January 14, 2015 BOARD OF COUNTY COMMISSIONERS ORANGE COUNTY, FLORIDA Addendum No. 1, IFB Y15-740-SB ORANGE COUNTY PARKS AND RECREATION WAREHOUSE HVAC REPLACEMENT

This addendum is hereby incorporated into the bid documents of the project referenced above. The following items are clarifications, corrections, additions, deletions and/or revisions to, and shall take precedence over, the original documents. <u>Underlining</u> indicates additions, deletions are indicated by <u>strikethrough</u>.

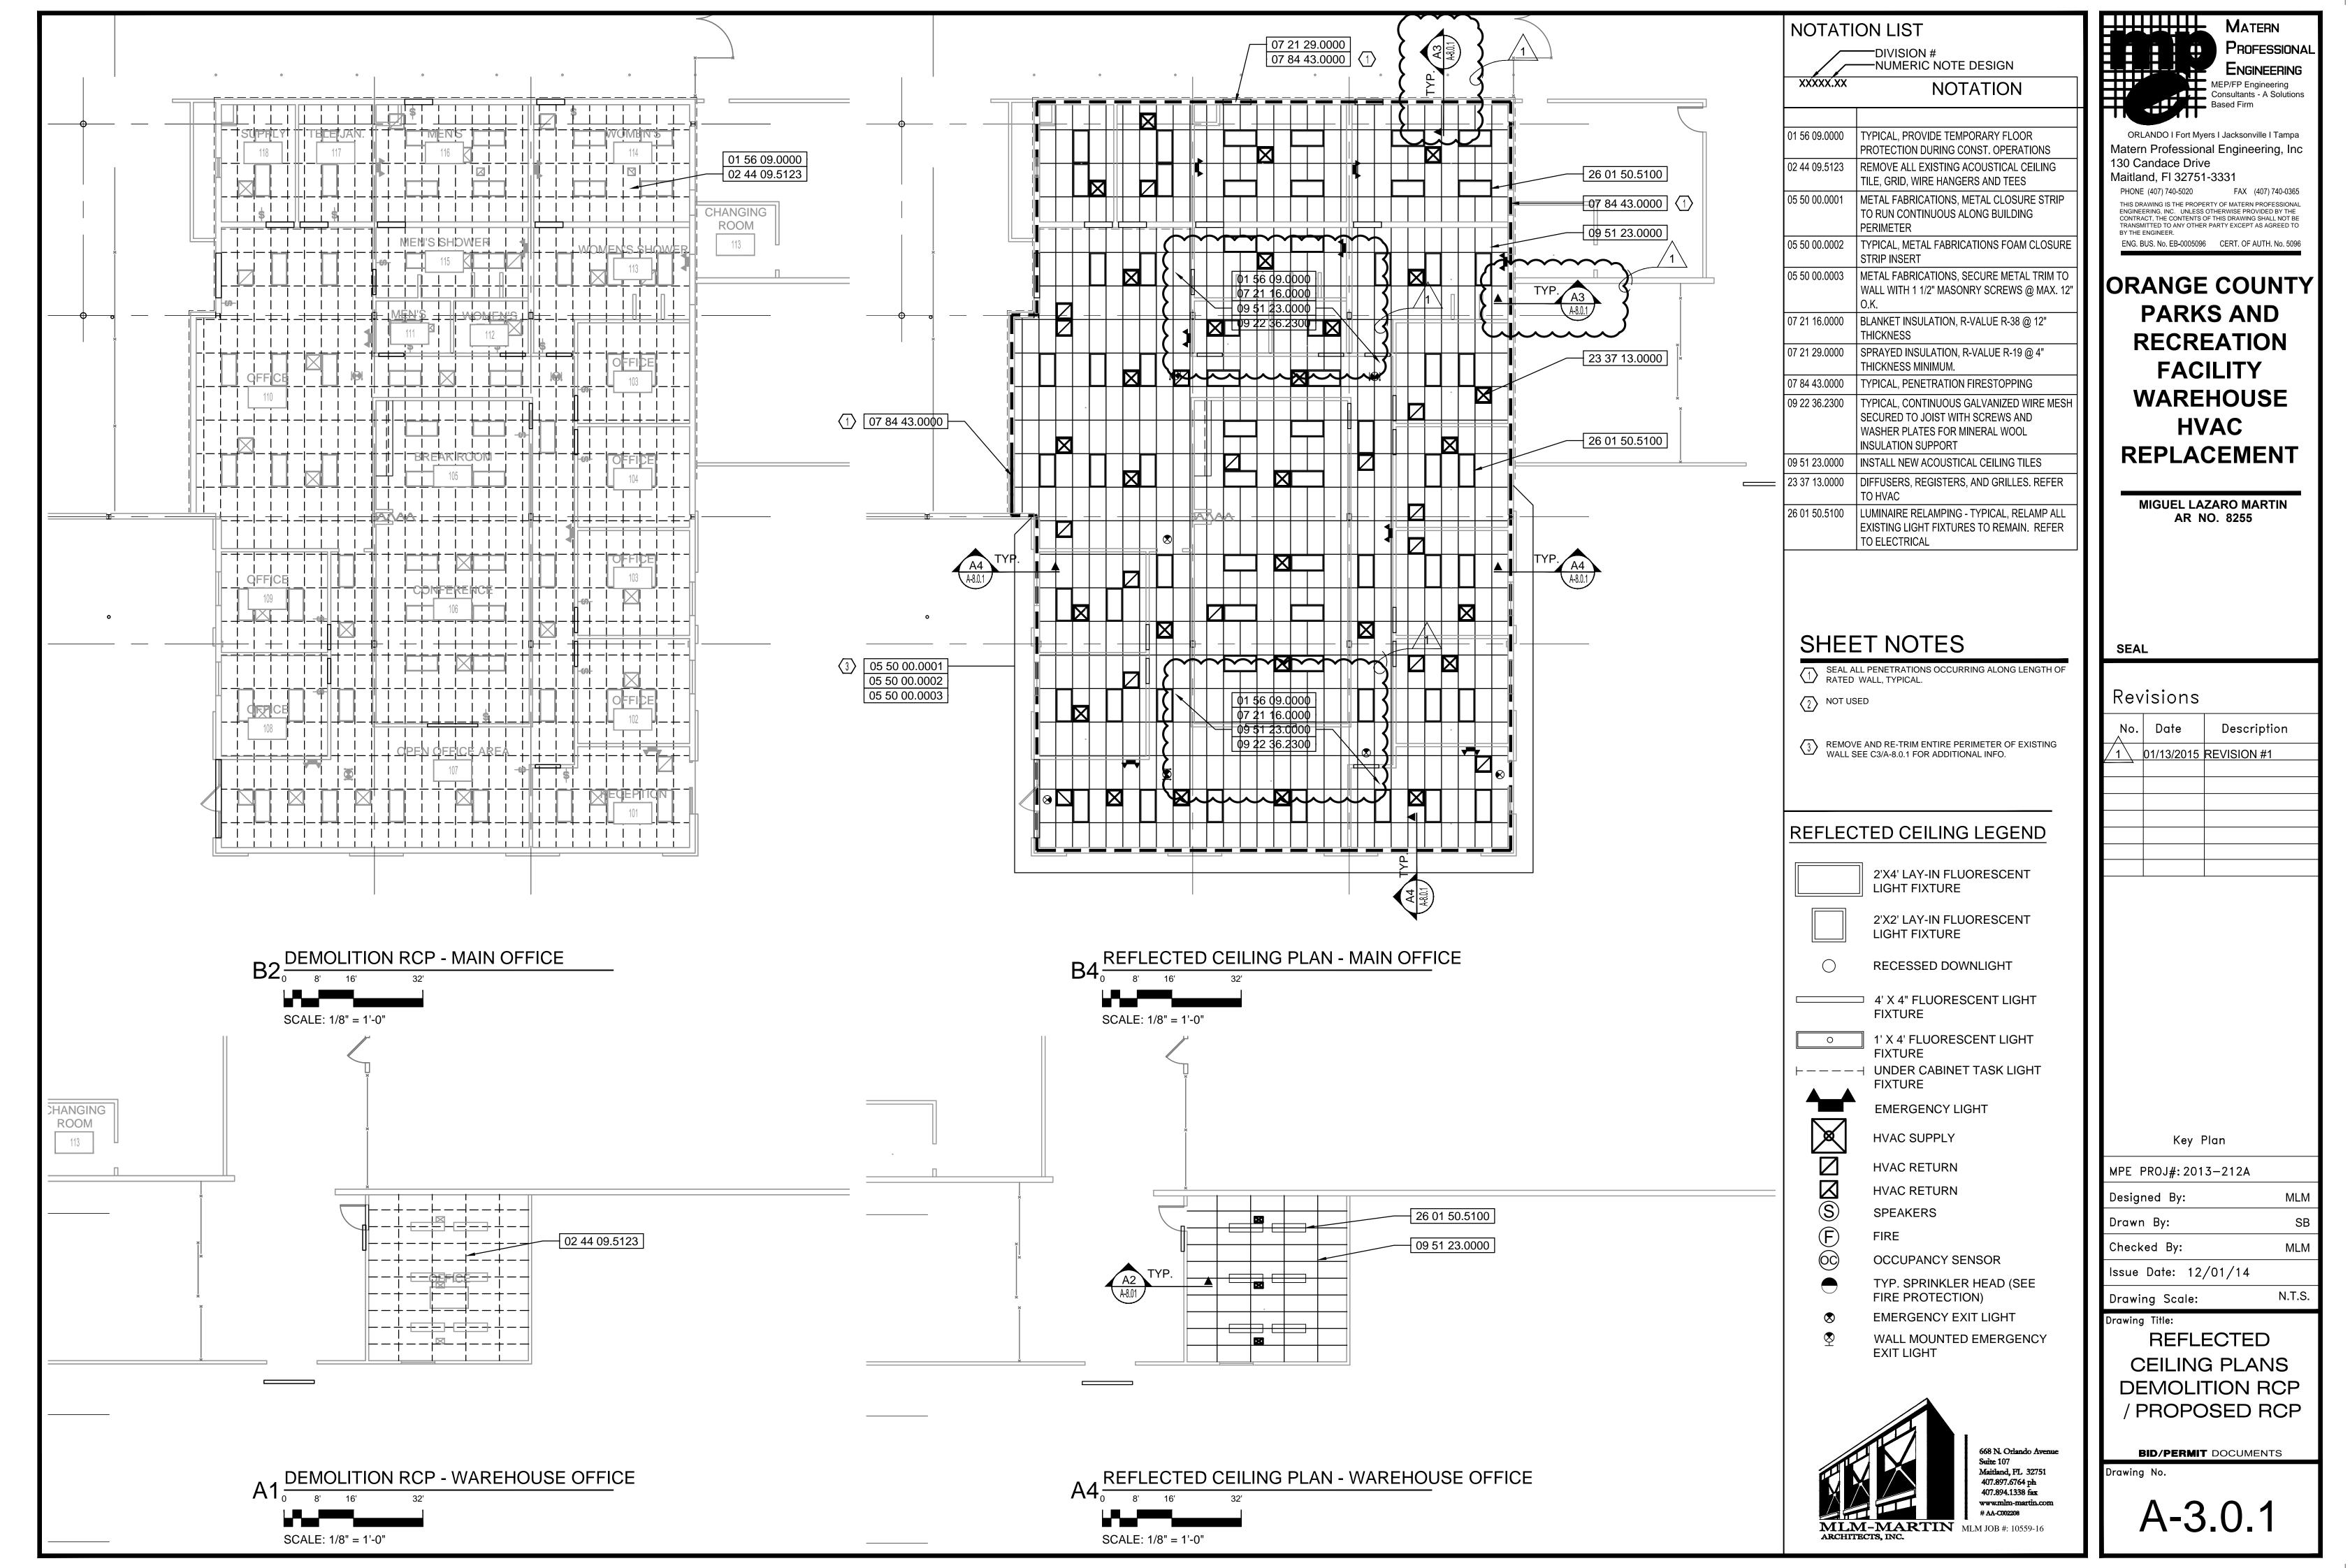
2. Question: Reference A4/A-3.0.1, please provide section through wall at interior. Section A4/A8.0.1 indicates a typical exterior wall section with new insulation to be installed within the joist supported by wire mesh screening. Is this insulation to be installed throughout the office space or only near the exterior walls?

- Sheet A-3.0.1 Dated 12-01-2014 with Revision 1 date of 1/13/2015: ADD: New interior wall section identification marker depicting wall assembly on the interior of warehouse facility space.
 Remove: Conflicting sheet note 09 01 50.9100 identifying existing ACT for patch and repair.
- Sheet A-8.0.1 Dated 12-01-2014 with Revision 1 date of 1/13/2015: ADD: Typical wall section on interior of warehouse facility space added for clarity.

Answer: Drawing Sheets A-3.0.1 & A-8.0.1 (attached) have been revised to address this. Summary of changes is noted below:
